ORIGINATION FORM

Proposed Revisions to a Standard Plans Index (Please provide all information — Incomplete forms will be returned)

Index Number: 102-600

Index Title: General Information for Traffic Control Through Work Zones

3 POST SIGN SUPPORT MOUNTING DETAILS

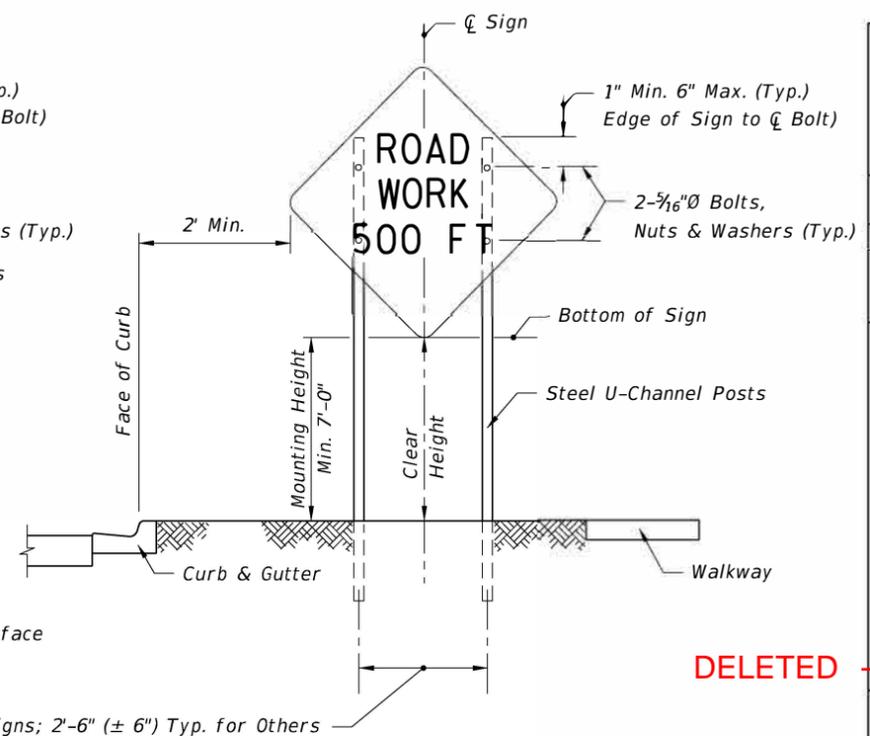
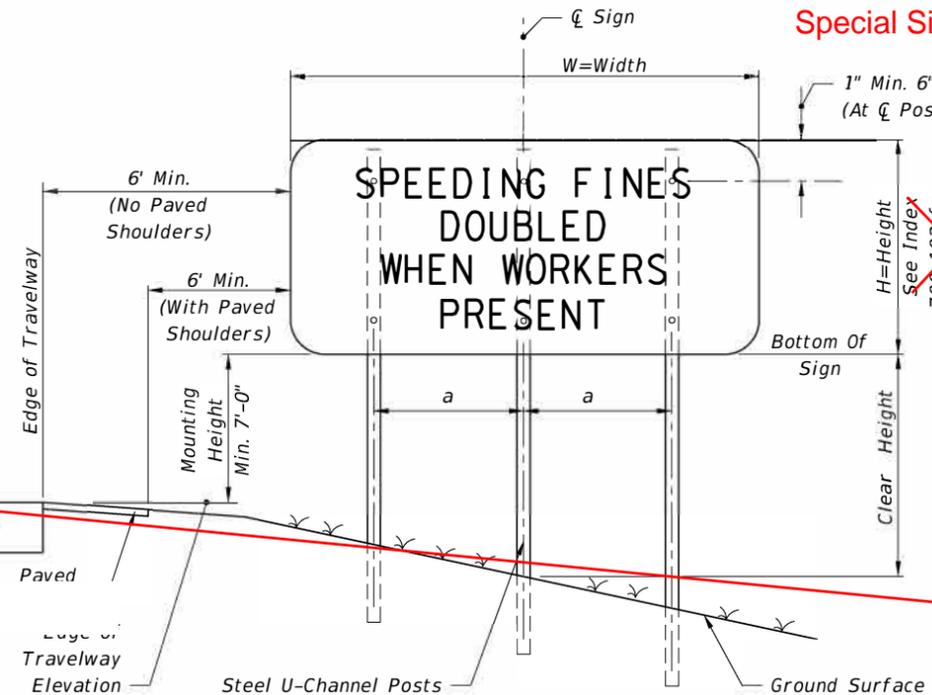
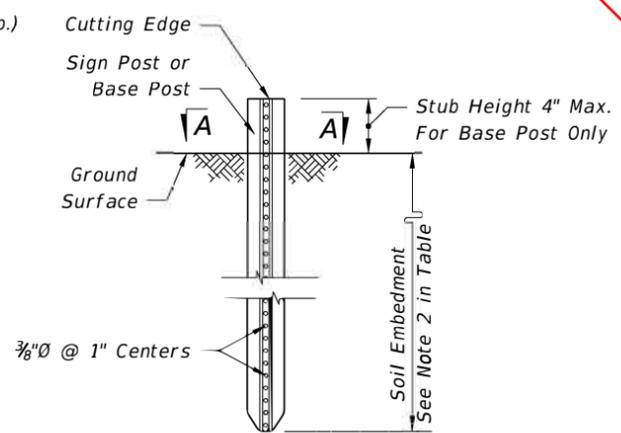
Sheet 5: Changed the Height reference note to "See Index 700-102 for Special Sign Details" and deleted the 60" Width in the 3 POST SUPPOR MOUNTING DETAILS; Moved TEMPORARY SIGN SUPPORT NOTE 9 to TABLE 7, as Note 5; Deleted the 60x64 and the 120x60* Rectangle signs and associated note from TABLE 7; Deleted "(See Note 7)" reference from the Diamond sign in TABLE 7.

Where $W = 48": a = 1' - 4\frac{1}{2}" (\pm 1")$
 ~~$W = 60": a = 1' - 9" (\pm 1")$~~
 $W = 72": a = 2' - 1" (\pm 1")$

Deleted

See Index 700-102 for Special Sign Details

COMMONLY USED WARNING AND REGULATORY SIGNS IN WORK ZONES

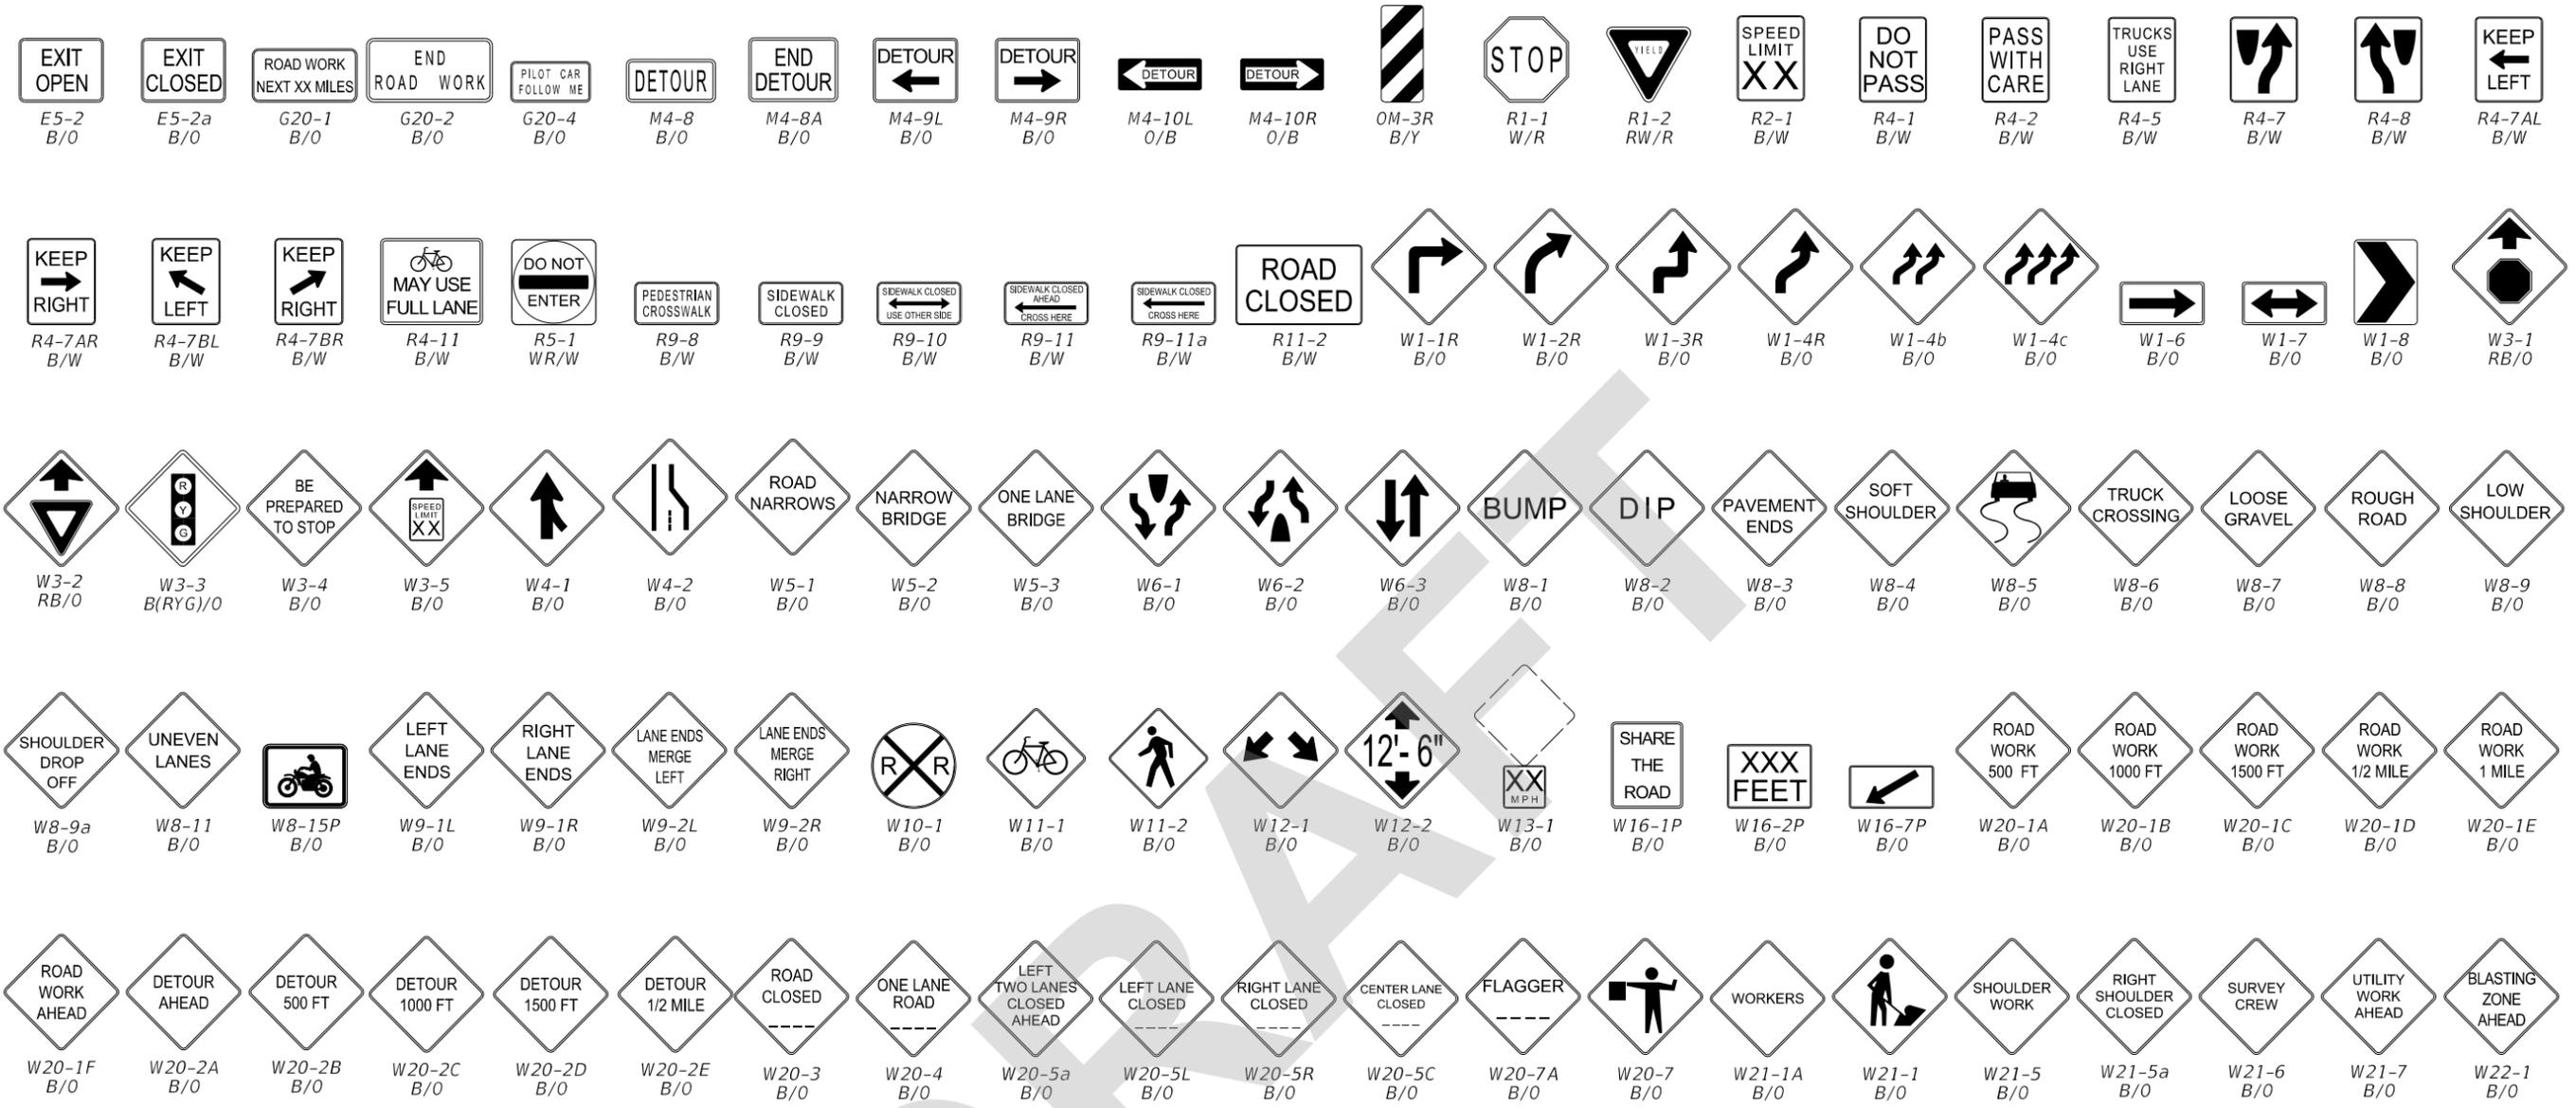
Sheet 6: Rearranged all signs: Added signs: R4-11, W11-1, and W16-1p: Deleted all of the "MOT" signs.

REARRANGED

ADDED SIGNS:
 R4-11
 W11-1
 W16-1P

DELETED ALL OF THE MOT SIGNS

SIDE ROAD INTERSECTING THE WORK ZONE

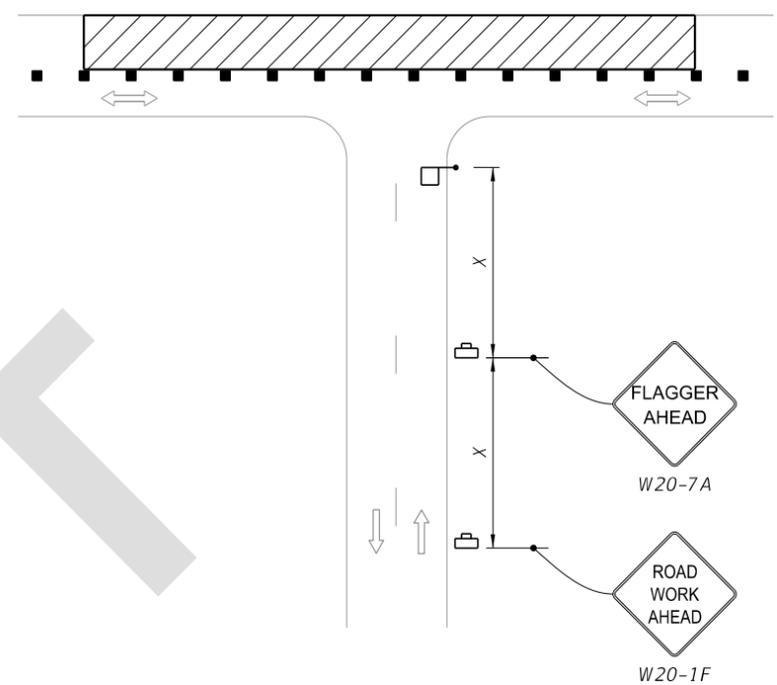
Sheet 7: Added the SIDE ROAD INTERSECTING THE WORK ZONE details form Index 102-606.

ADDED:
SIDE ROAD INTERSECTING THE WORK ZONE
 detail from Index 102-606
